Document 00910

ADDENDUM NO. Date of Addendum: \(\square\frac{\pi_{\infty}}{20} \)

PROJECT NAME: Almeda Road Paving and Drainage Improvements Old Spanish Trail to South MacGregor Way PROJECT NO: WBS No. N-000806-0001-4; CSJ No. 0912-72-072 BID DATE: May 28, 2015 J. Timothy Lincoln, P.E., City Engineer FROM:

TO: **Prospective Bidders**

SHEET 2 OF
WBS NUMBER	FOR CITY OF HOUSTON USE ON
N-000806-0001-4	
DRAWING SCALE	
VERT: AS NOTED HORZ: AS NOTED	
CITY OF HOUSTON PM	
MICHELLE RANDON, P.E.	
SHEET NO.22A OF 271

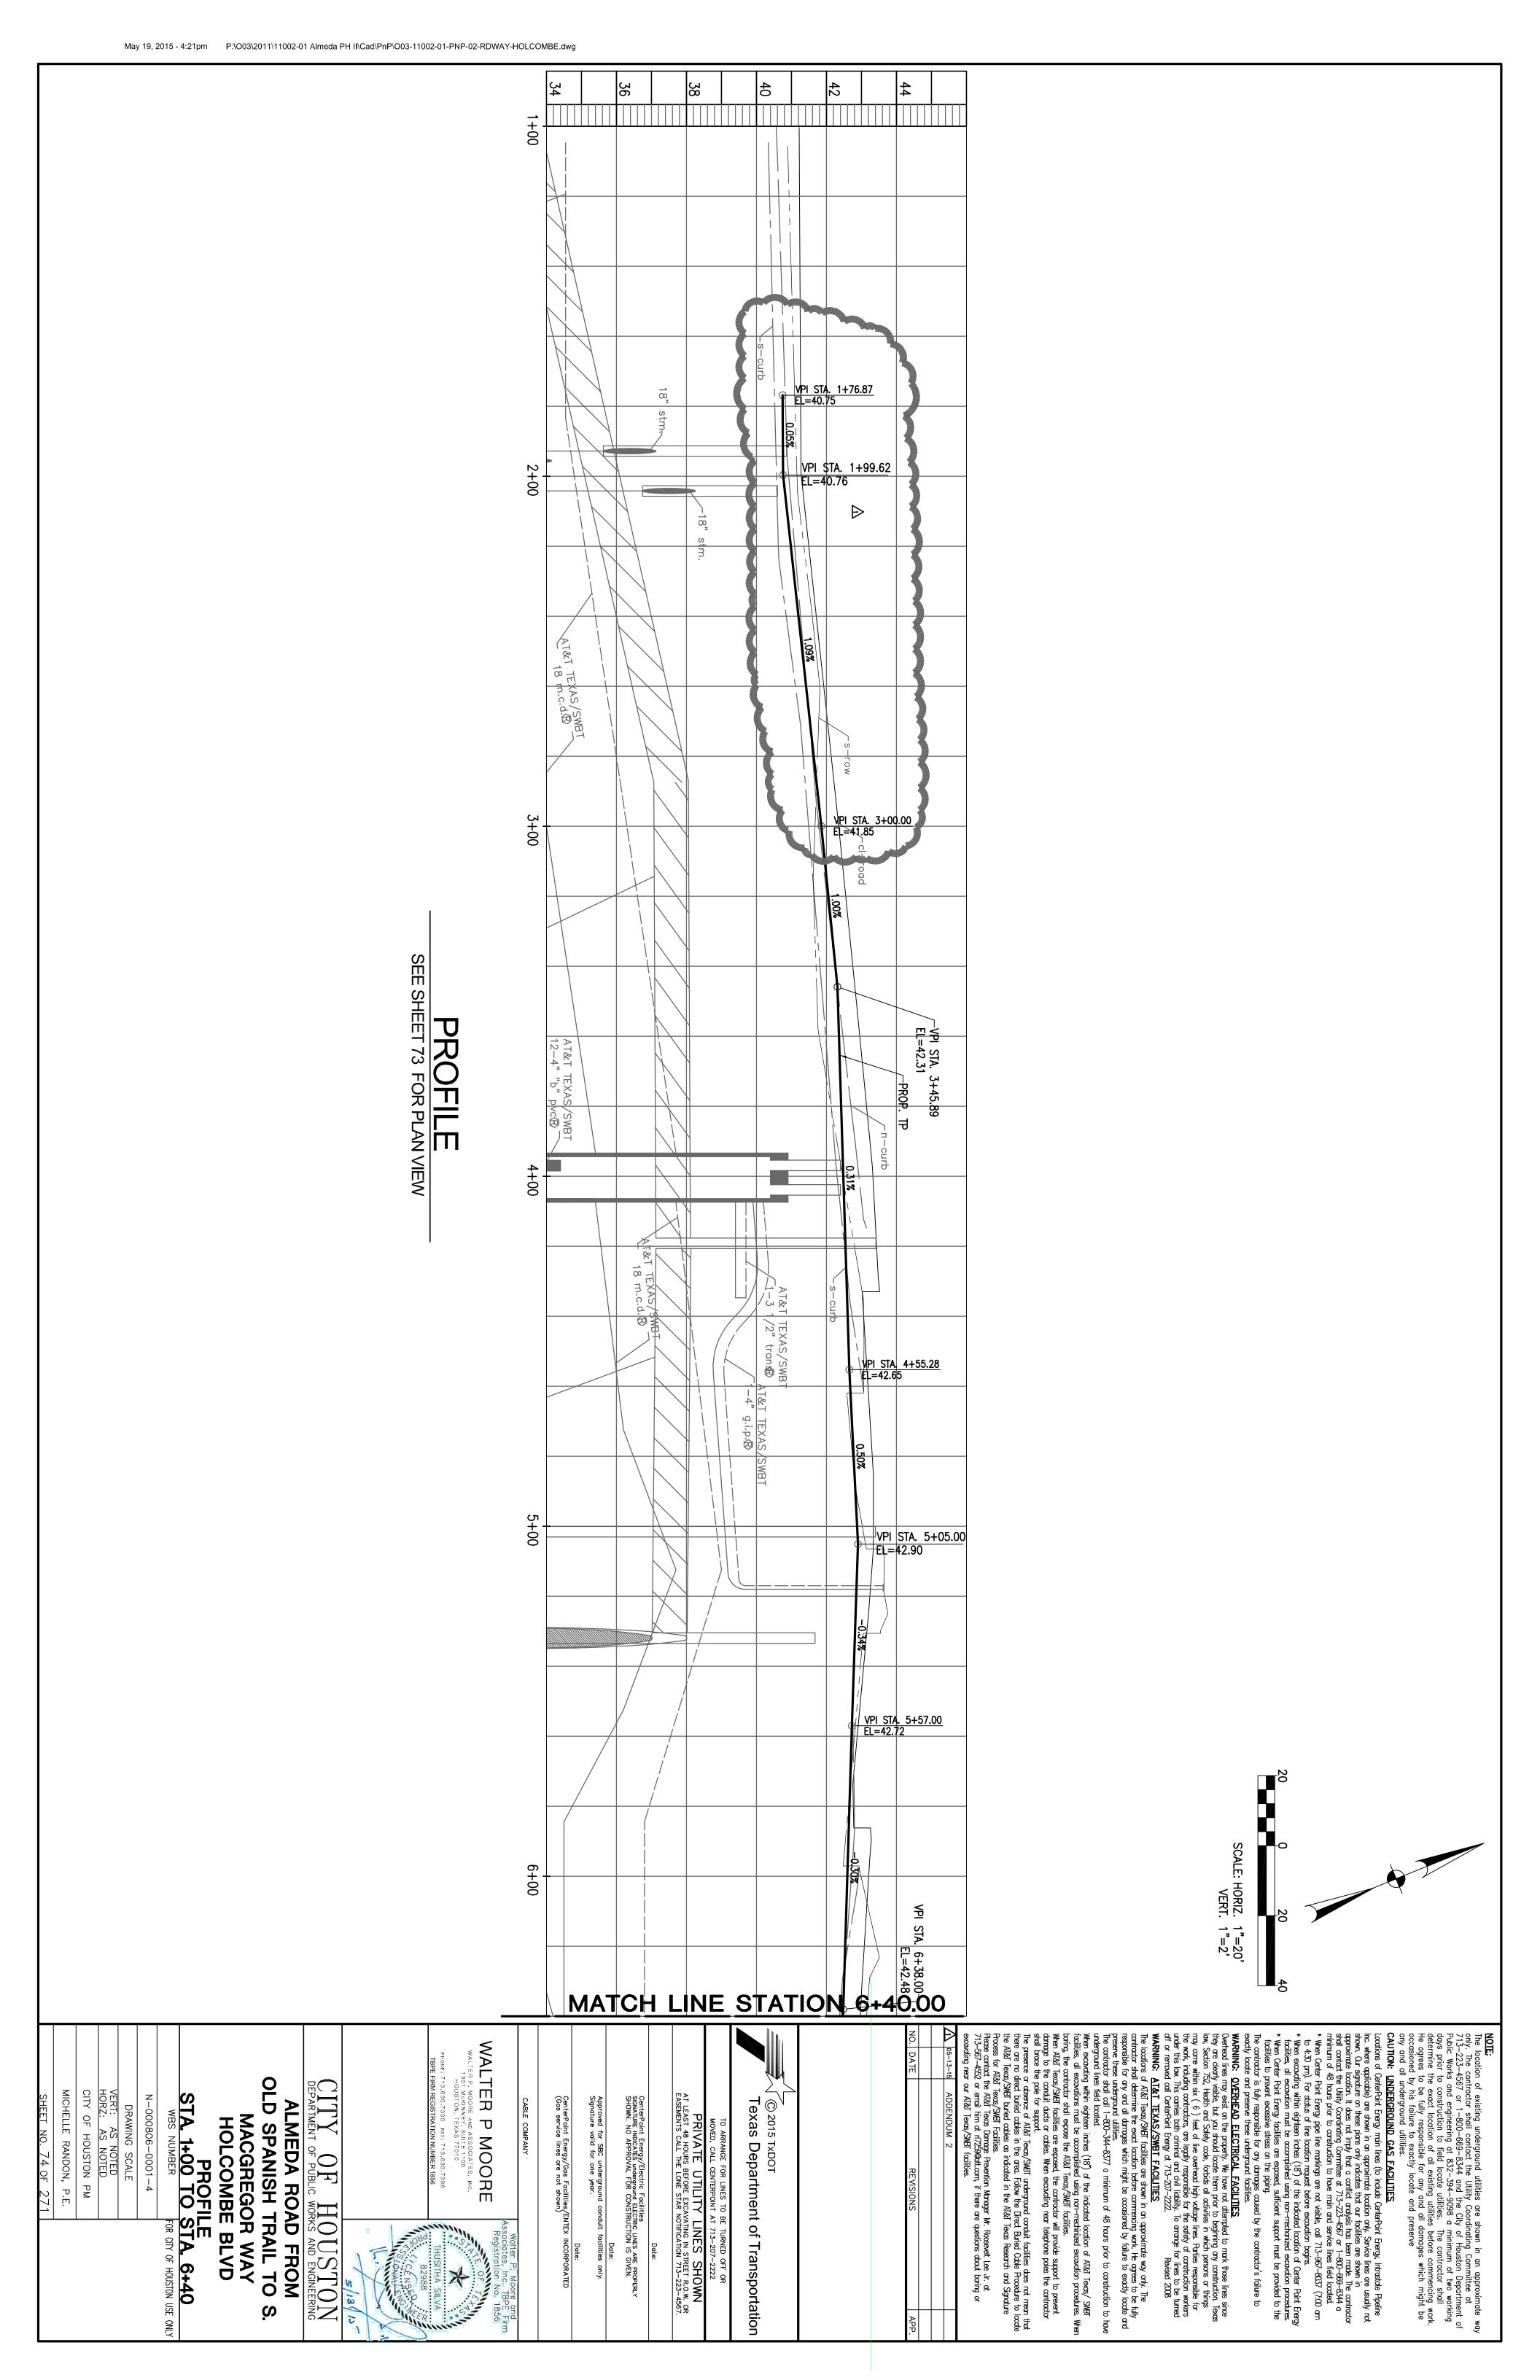
- 1. Sheet 21- Revised Holcombe Boulevard typical section, STA 6+37.98 to END PROJECT, to reflect added pavement and sidewalk reconstruction.
- 2. Sheet 22 Revised DEMOLITION QUANTITY.
- Sheet 22 A Revised STORM SEWER & STREET & BRIDGE QUANTITY
- 4. Sheet 47 Added driveway at station 16+04.59 & added shaded area to reflect limits of High Early Strength Concrete placement limits.

WBS NUMBER	FOR	CITY	OF	HOUSTON	USE	ONL
N-0000806-0001-4						
DRAWING SCALE						
VERT: AS NOTED HORZ: AS NOTED						
CITY OF HOUSTON PM						
MICHELLE RANDON, P.E.						
SHEET NO. 122 OF 271

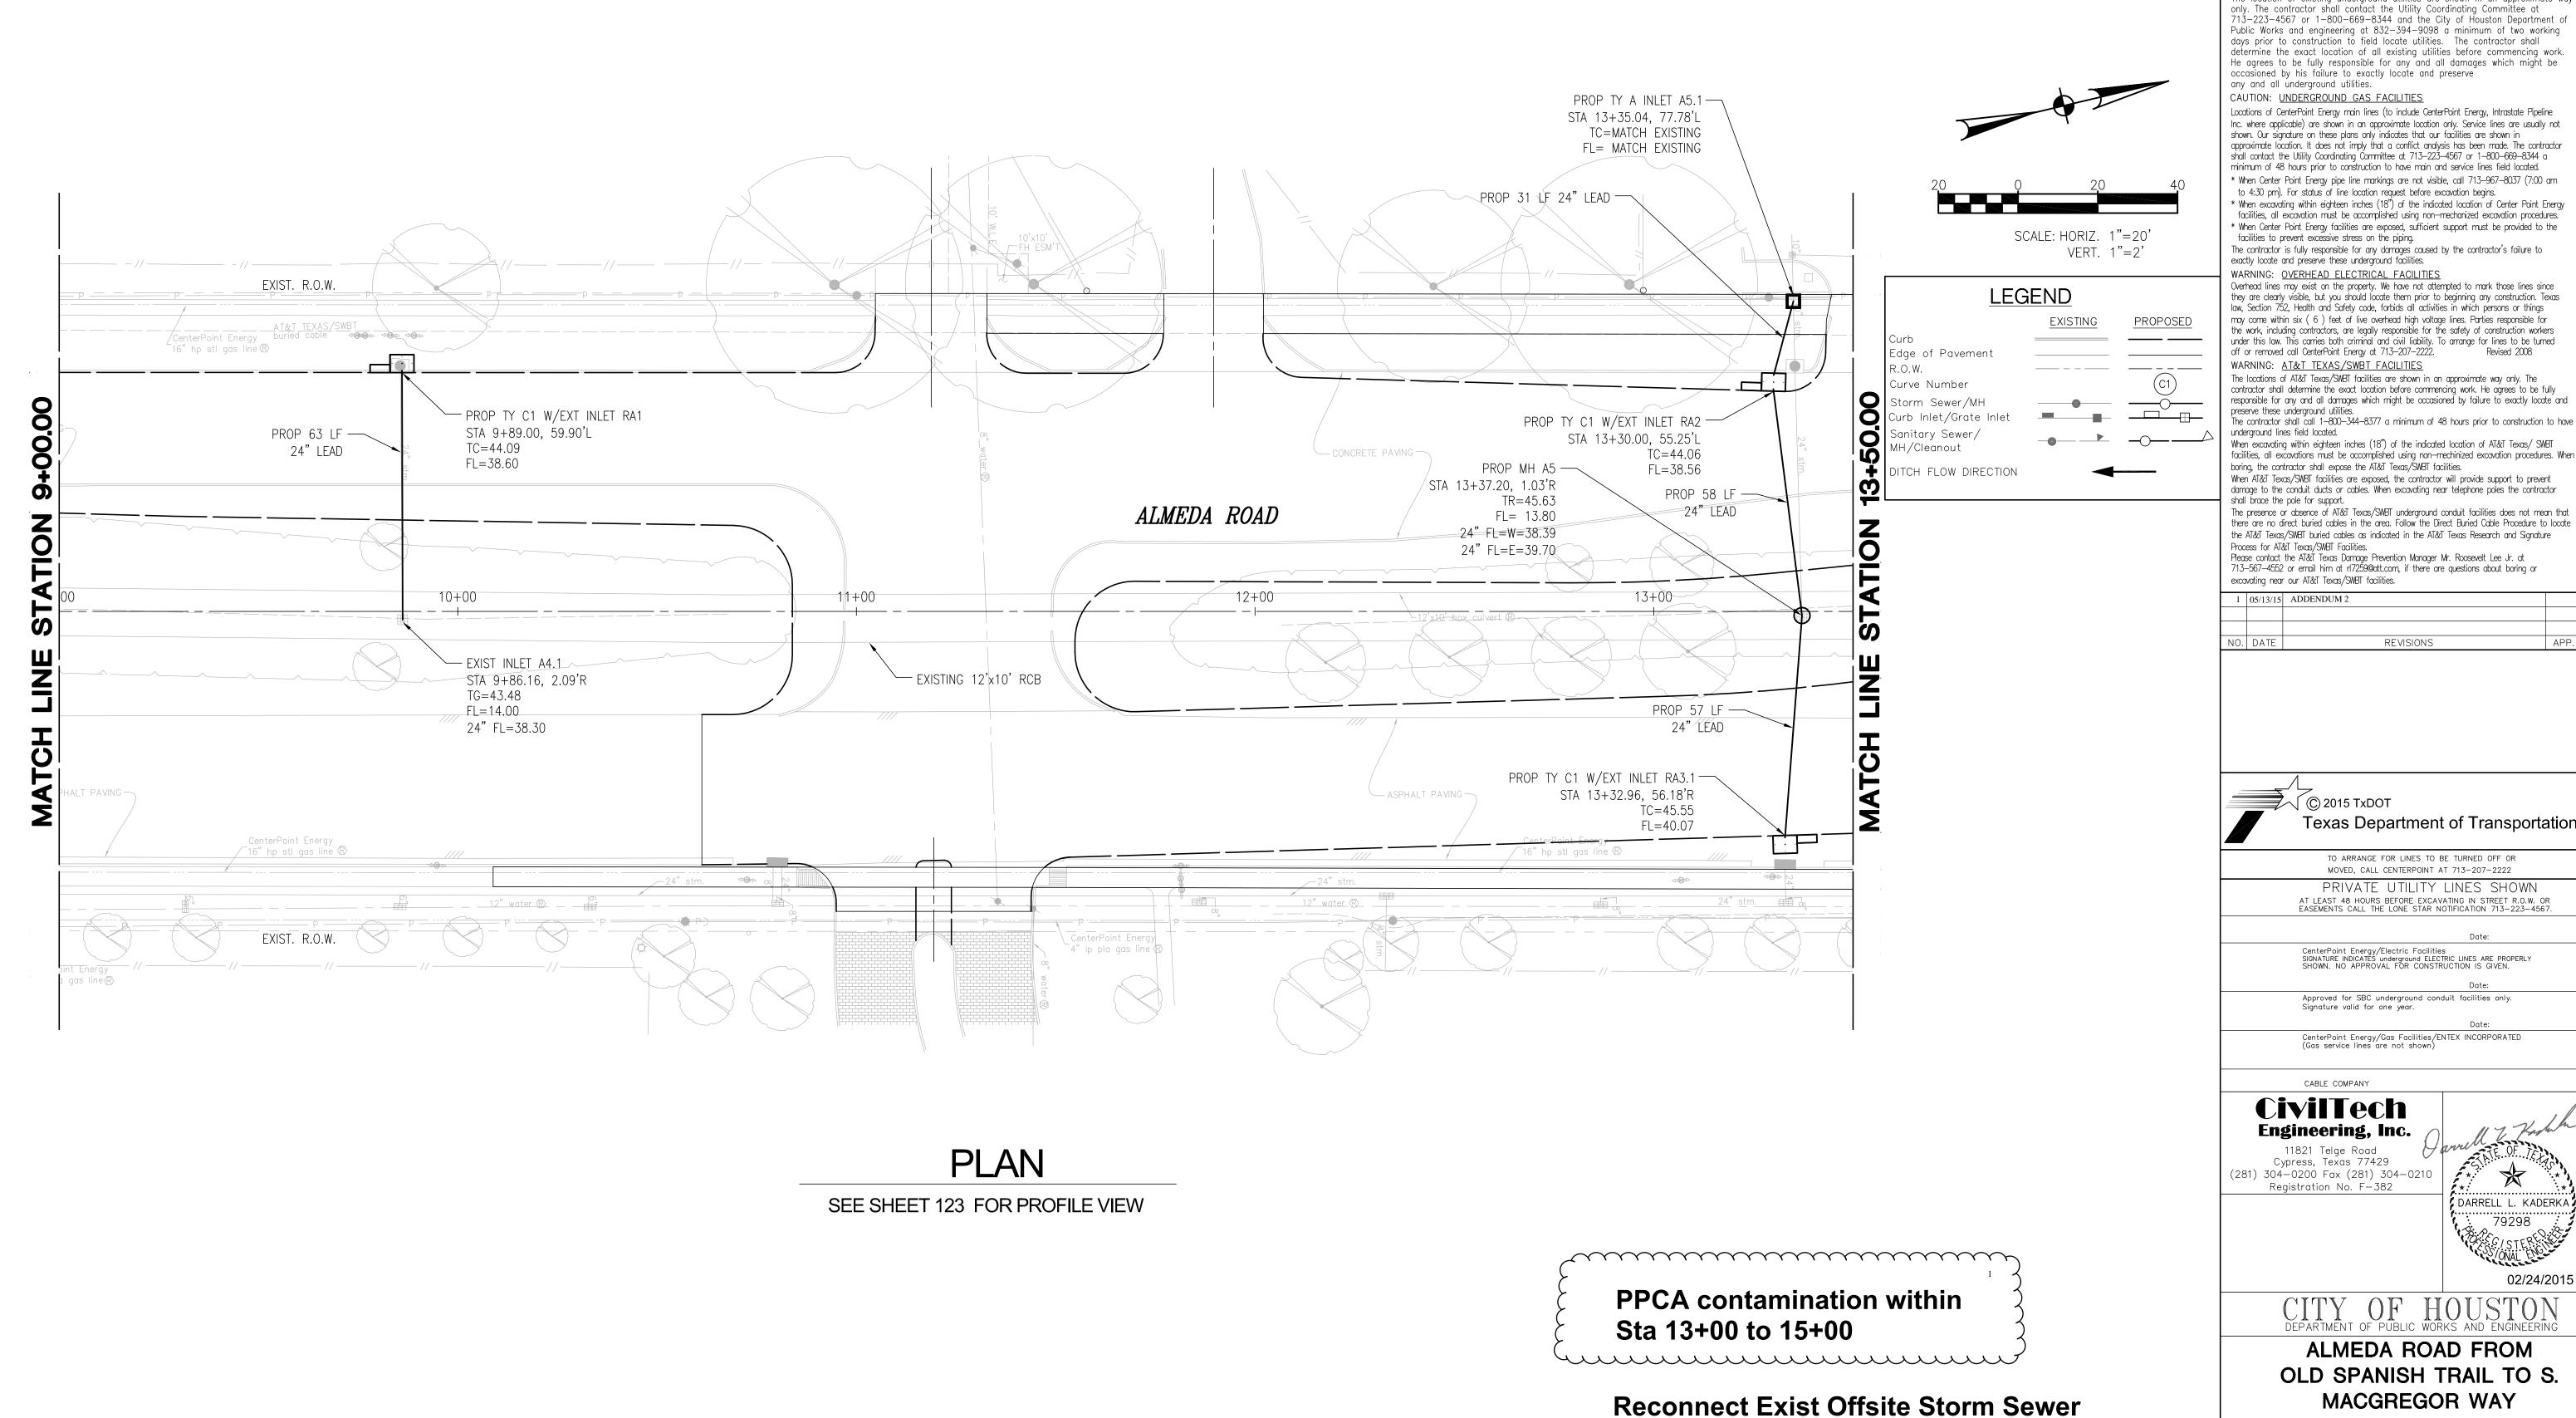
- 5. Sheet 49 Added shaded area to reflect limits of High Early Strength Concrete placement limits.
- 6. Sheet 53 Added shaded area to reflect limits of High Early Strength Concrete placement limits and proposed pavement type call outs.
- 7. Sheet 59 to Sheet 73 Added shaded area to reflect limits of High Early Strength Concrete placement limits.
- 8. Sheet 74 & Sheet 76 Extended profile to cover project construction limits.
- 9. Sheet 75 Extended limits of construction to STA 9+25 and added shaded area to reflect limits of High Early Strength Concrete placement limits.
- 10. Sheet 79- Revised "TC" to "TP"
- 11. Sheet 87 Extended limit of demolition to station 9+25
- 12. Sheet 122 & 124- Clarified PPCA limits
- 13. Sheet 136 Revised 24" RCP pipe connection point on Holcombe Blvd.
